# C2M spec consistency and tolerancing

# 400GAUI-8 C2M issues

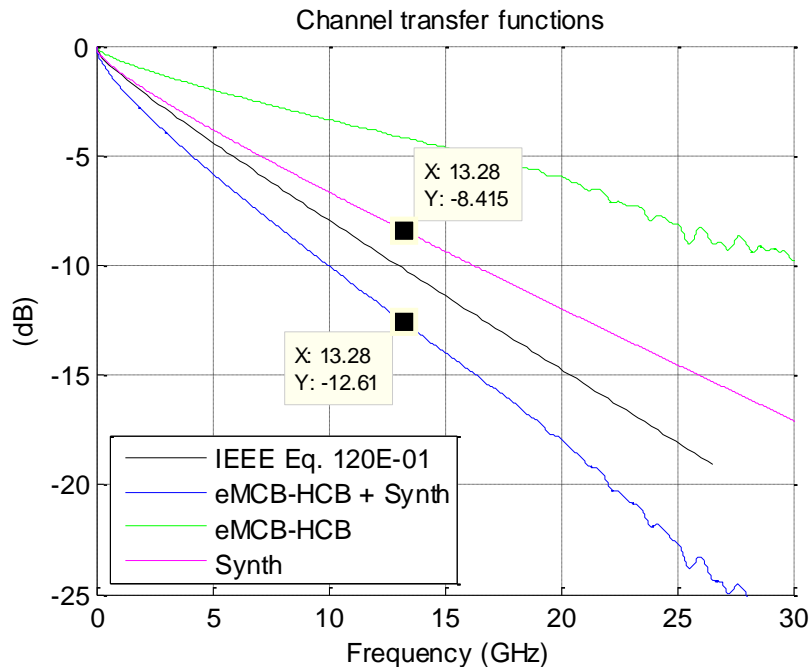
- Concerns with stressed input tests in Annex 120E D3p2

and subsequent work said that it would be difficult to impossible to make a module stressed input signal without removing all or nearly all jitter and nonlinearity

# Near and far end eyes, 2-tap FFE

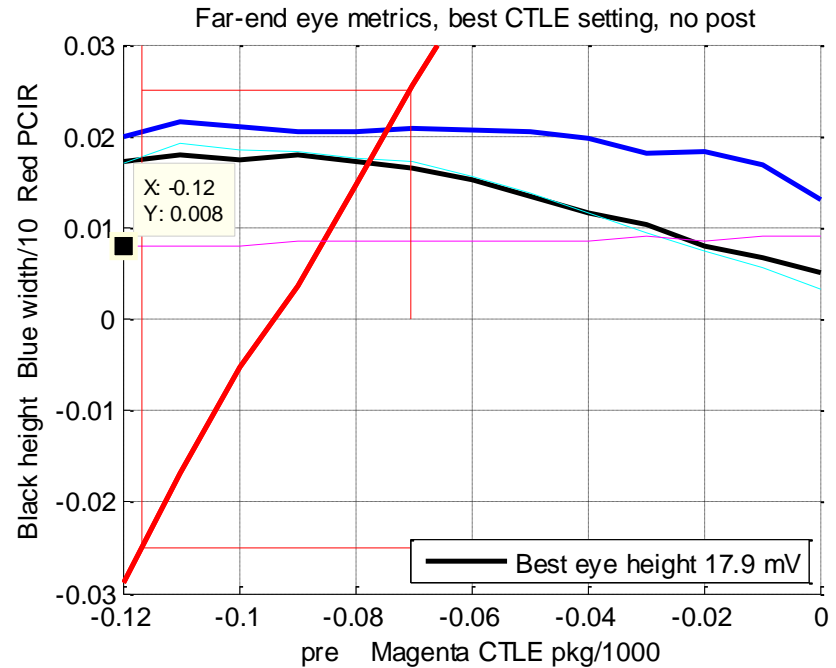
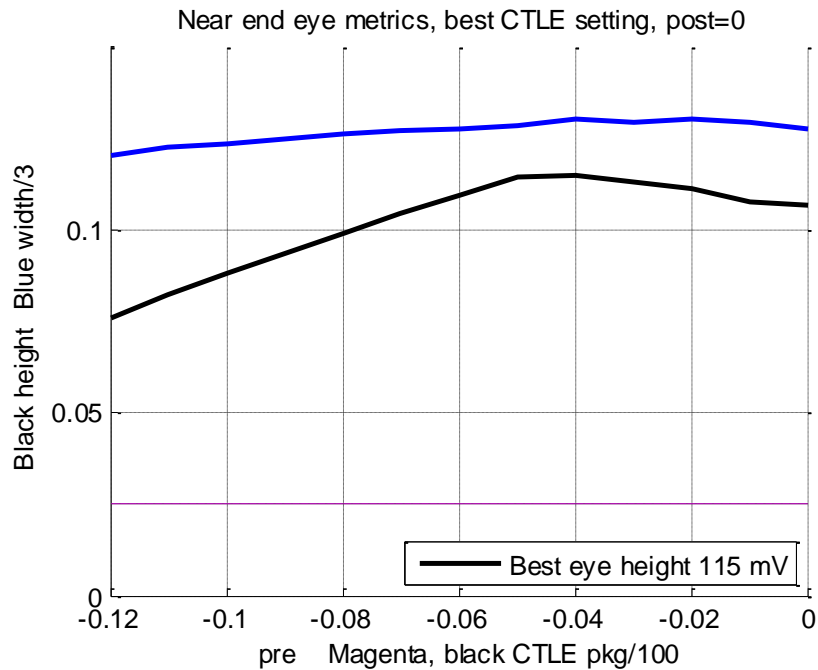
- With 2 dB extra "soft" channel loss. CTLE selected for best  $EH \cdot EW$ : 8 or 8.5 dB in the range between the red lines
- Eye heights and widths could be higher or lower than these
- Range of FFE precursor settings that satisfies far-end ISI pre-cursor ISI ratio rule is only 0.0463. This is less than the 0.05 step size for the C2C Tx emphasis control, without allowing anything for tolerancing
- The far-end ISI pre-cursor ISI ratio rule (+/-2.5%) is too tight
